ADDENDUM NO. 1

April 12, 2021

HANOVER CENTRAL HIGH SCHOOL ADDITIONS AND RENOVATIONS Cedar Lake, IN 46303

© GIBRALTAR DESIGN
SHEET
S-401

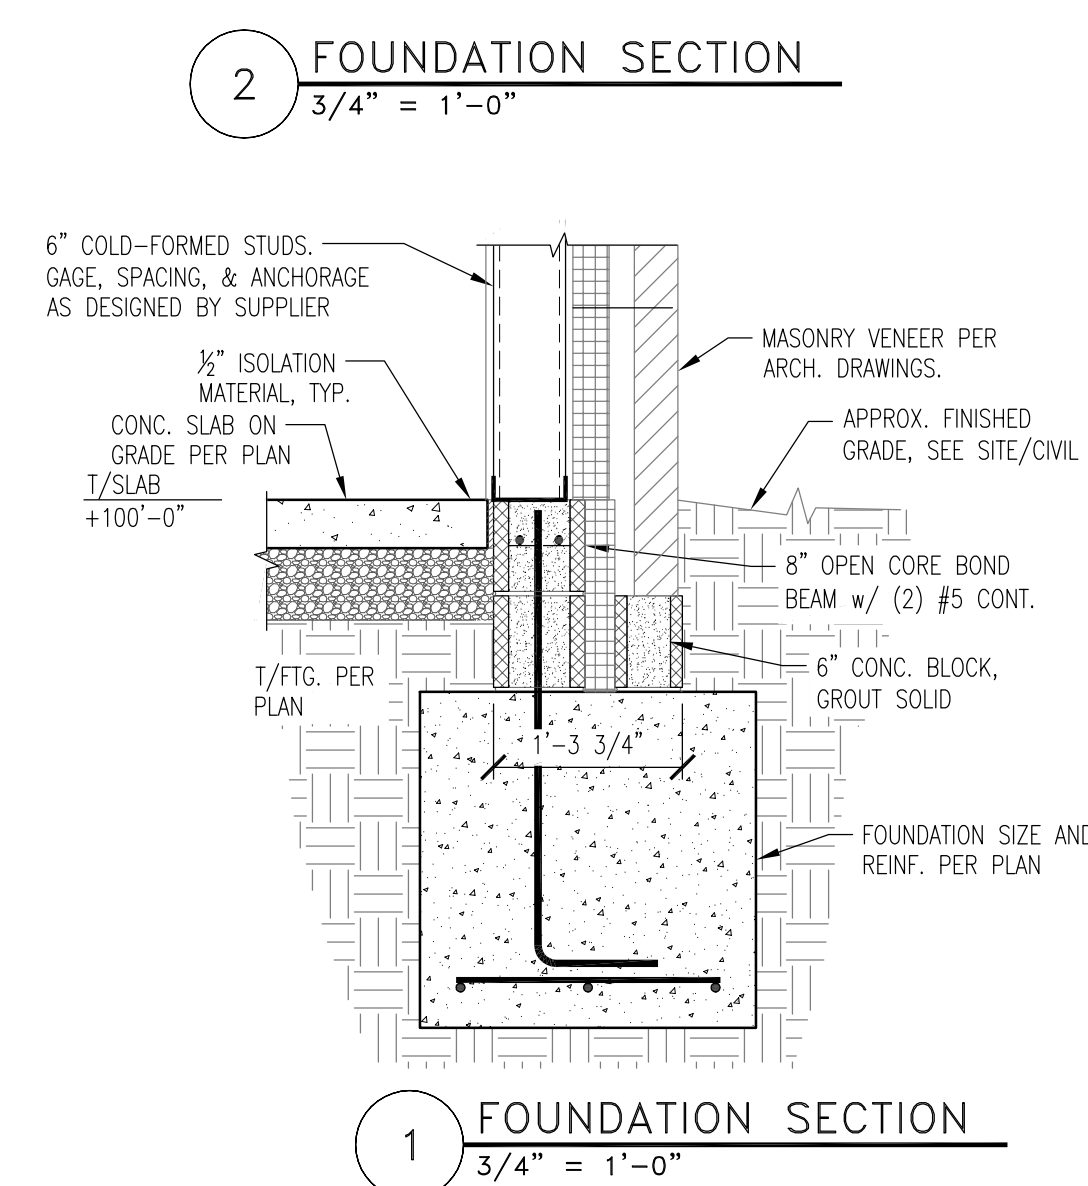
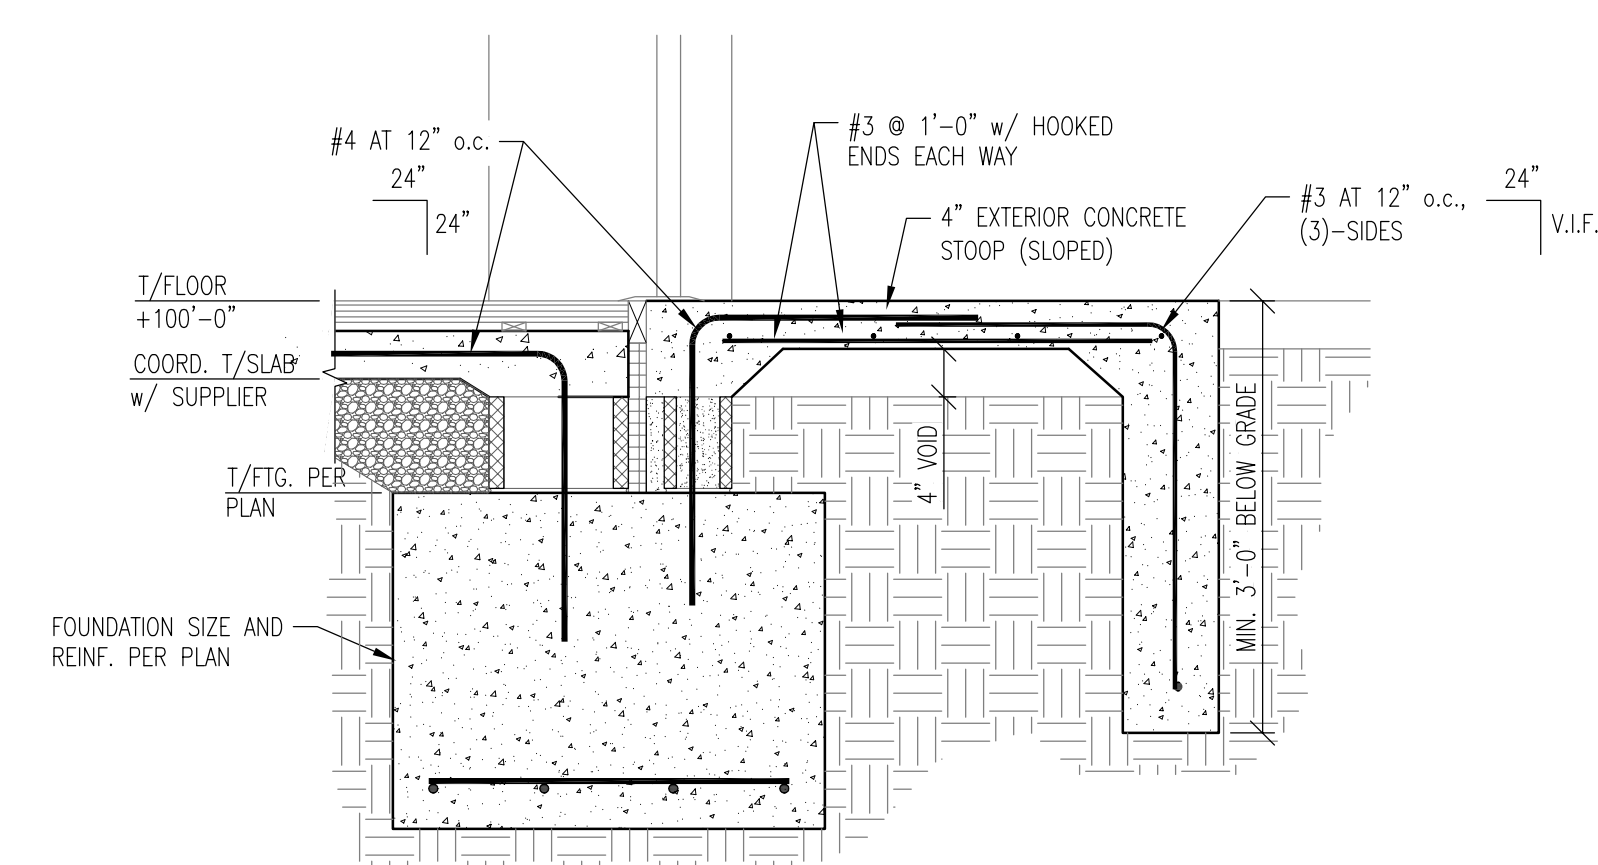
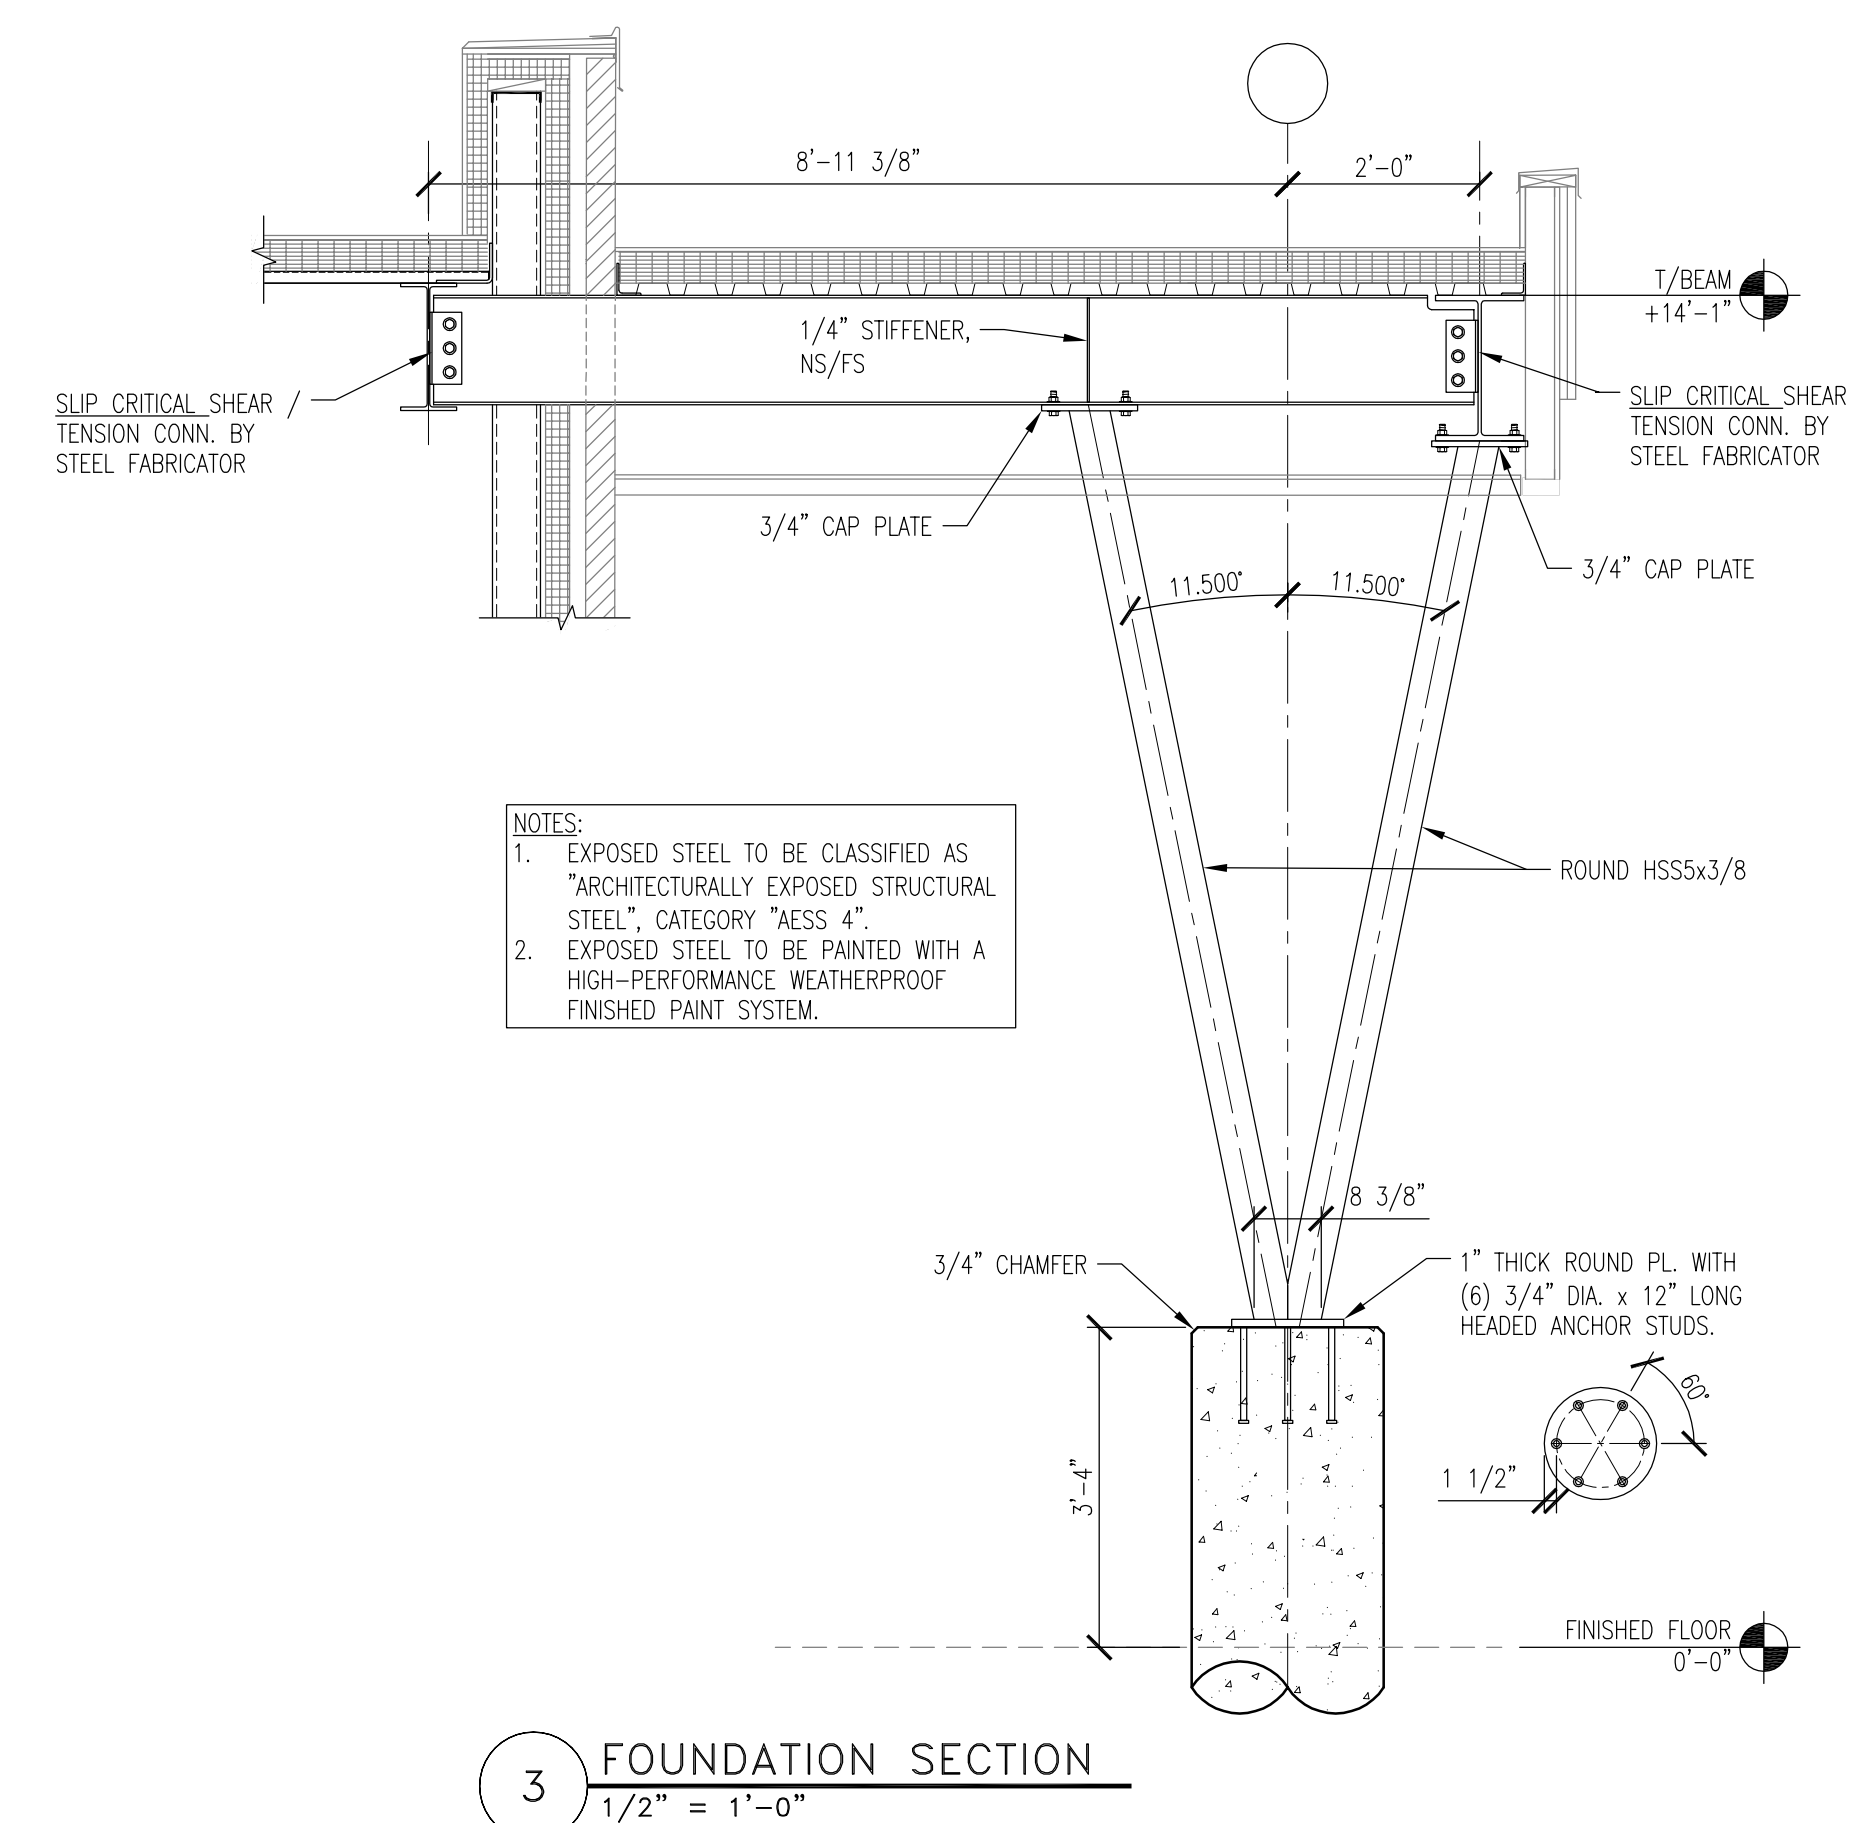
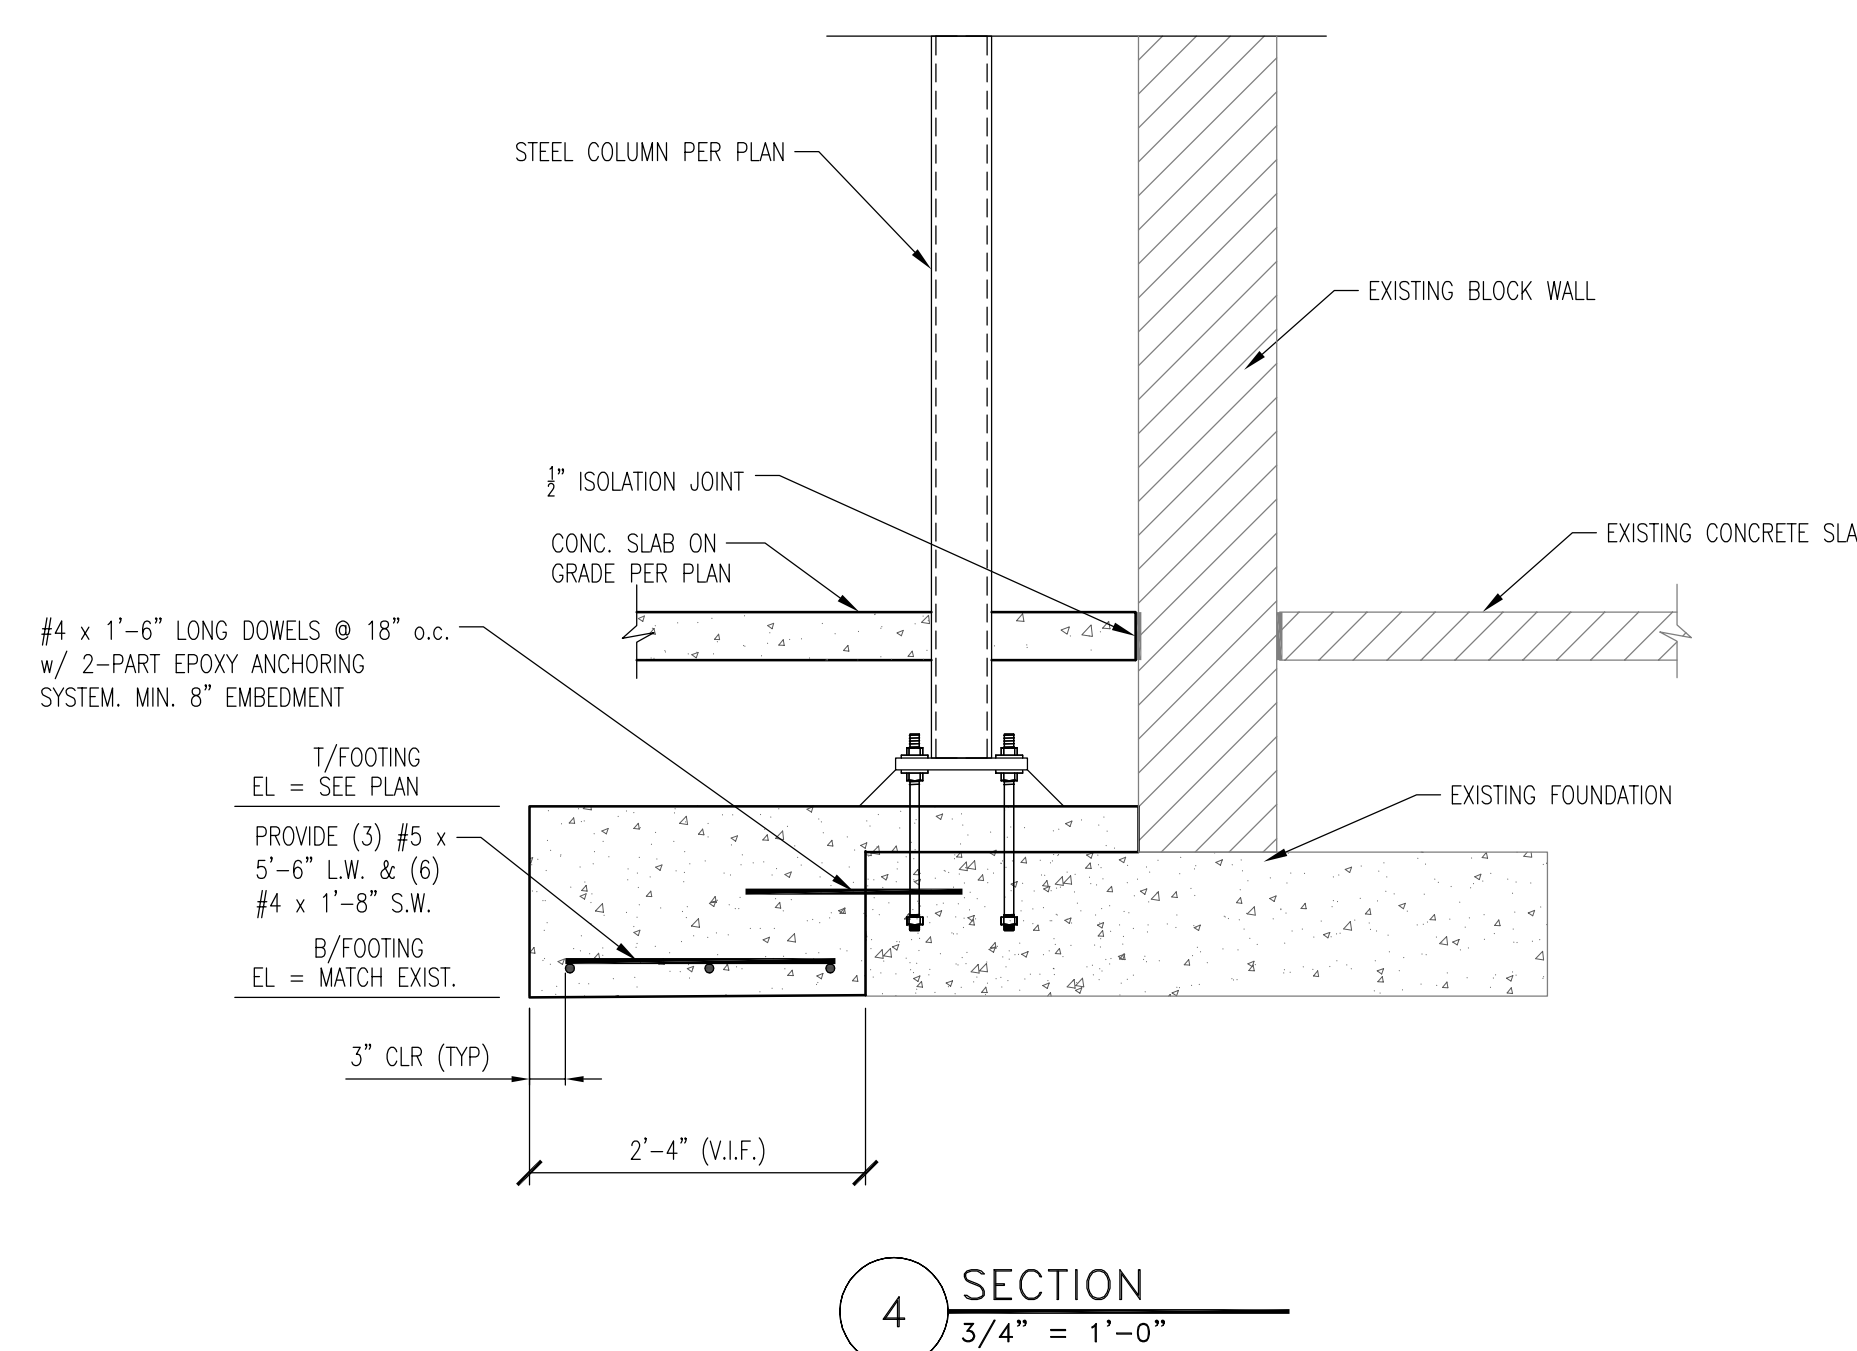
- A. Refer to revised full size drawing, included in this Addendum, for the following revisions:
 - 1. Section 5/S-401 was added.
 - 2. Section 6/S-401 was added.
 - 3. Section 7/S-401 was added.
